1. DETAILS OF THE DEVELOPMENT

Ref: 18/05248/PRE
Location: 28 Boulogne Road, Croydon, CR0 2QT
Ward: Selhurst
Description: Complete demolition of existing buildings on the site, redevelopment including erection of four blocks up to five stories in height providing 59 self-contained residential units (C3) and 3 commercial units.
Drawing Nos: Bou-HKR-XX-01-PL-A-1000, 1001, 1002, 1003, 1004 + CGIs
Applicant: Evolve Housing – Alice Hainsworth
Agent: Stile Harold William Partnership – Chris Heather
Case Officer: Barry Valentine

Image 2 – Model images of development massing from Hampton Road.

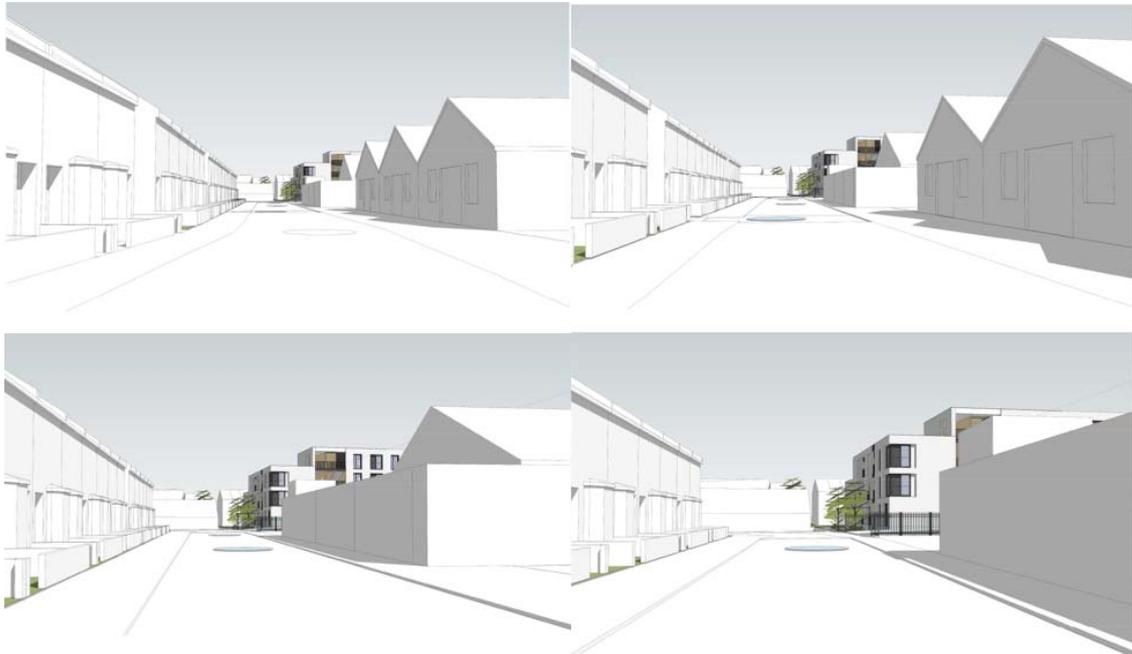
- 5.17 The site ground level generally sits a storey below the garden level of surrounding properties. These land levels are favourable and allows the development to be taller than otherwise normally would be appropriate. From Hampton Road, the development would predominantly read as three storeys in height, and would gradually step up in height from the two storey properties that form part of the wider Hampton Road context. The taller fifth storey element is

set centrally into the site and is in part obscured from views from Hampton Road by the roofs of the industrial buildings, as demonstrated in the series of images below.

Image 5 – Daylight and sunlight model, with element highlighted in yellow that is no longer proposed as part of the current submission.

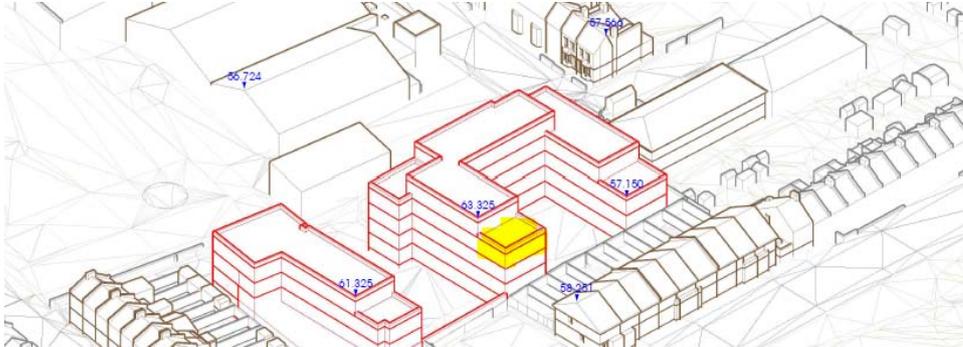
sunlight and daylight test is marginally larger in size than the scheme currently being presented before committee. The area in yellow in the image below was included in the sunlight and daylight model test, but has now been revised out of the scheme. Some of the data reported is likely to have improved as a result of this change, particularly for 37 F to H Princes Road.

Graph 1 – Distribution of proposed VSC scores (%) of windows that failed VSC test.

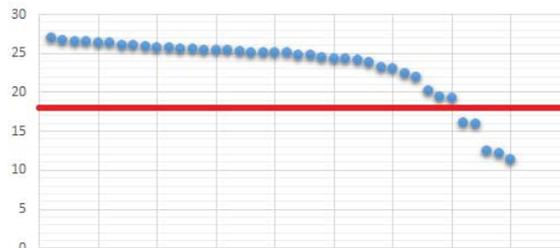
5.22 40 of the 110 windows that were tested under BRE’s VSC test fail, as they would achieve a VSC of less than 27%, and a ratio reduction of over 80%. As such these windows and the rooms they serve are likely to experience a noticeable reduction in daylight. However, the vast majority of the windows would still receive good level of daylight, with all but five windows retaining a VSC in excess of 18%, which is an amount of daylight that properties set within urban environments commonly experience. The five windows which fall below 18% are all ground floor windows located on different properties in Boulogne Road, thus the impact would to some extent be spread, and as such would have a limited impact of standard of residential accommodation that surrounds the site.

Graph 3 – Ratio reduction as % in garden overshadowing on spring equinox.

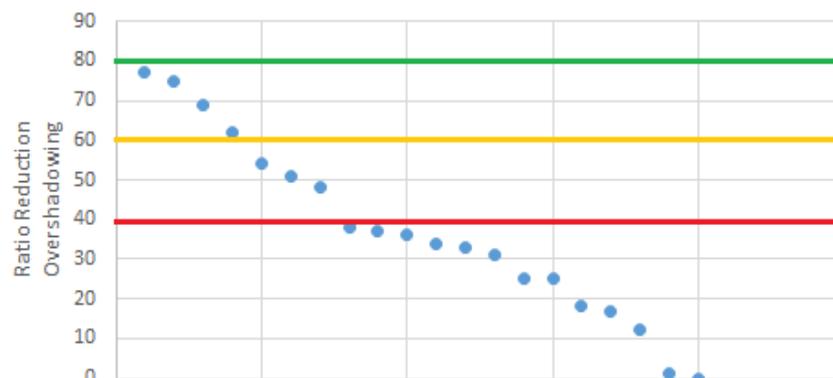
5.26 The submitted sunlight and daylight assessment includes a test that measures the extent that the development would overshadow neighbouring properties' gardens. The test measures the percentage of a garden which would receive 2 hours sunlight on spring equinox (21st March). If less than 50% of a garden receives less than 50% and the reduction is greater than 80% then this is considered to be a failure. Of the 27 gardens measures that surround the site, 21 would fail BRE overshadowing test. 4 of these failures are classed by officers to be minor, 3 would be moderate and 14 would be major. The results are plotted in graph 3 and the location of the moderate/major failures are shown on graph 4. The applicant has also run the optional test taken on the 21st June, which represents the time of year when shadows are at their shortest. At this time of the year, all gardens would meet the same standard.

Graph 4 – Locations of major (red) and moderate (yellow) BRE failures of overshadowing to gardens and Daylight Distribution to rooms (windows to the room only coloured in)

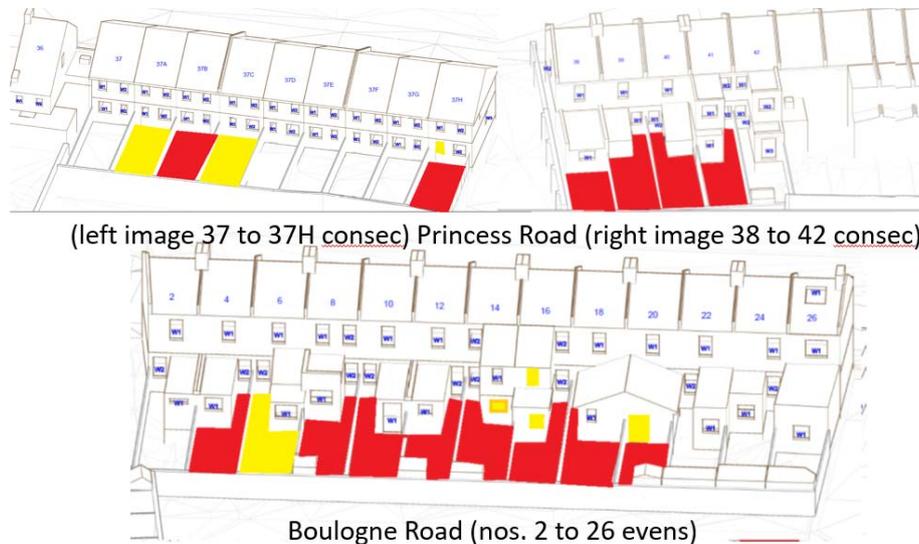
5.24 In terms of daylight distribution, of the 102 rooms assessed, there were only 15 failures. 10 of these failures are classed by officers to be minor, with the affected rooms scoring over 60% and 5 being moderate failures scoring over 40% and no major failures with a score below 40%. All the rooms that failed the daylight distribution test had windows that served them which also failed the VSC tests. The moderate fails in daylight distribution occurred on 37H Princes Road, 14, 16 (2 rooms), 18 and 20 Boulogne Road, the locations of which are shown on graph 4.
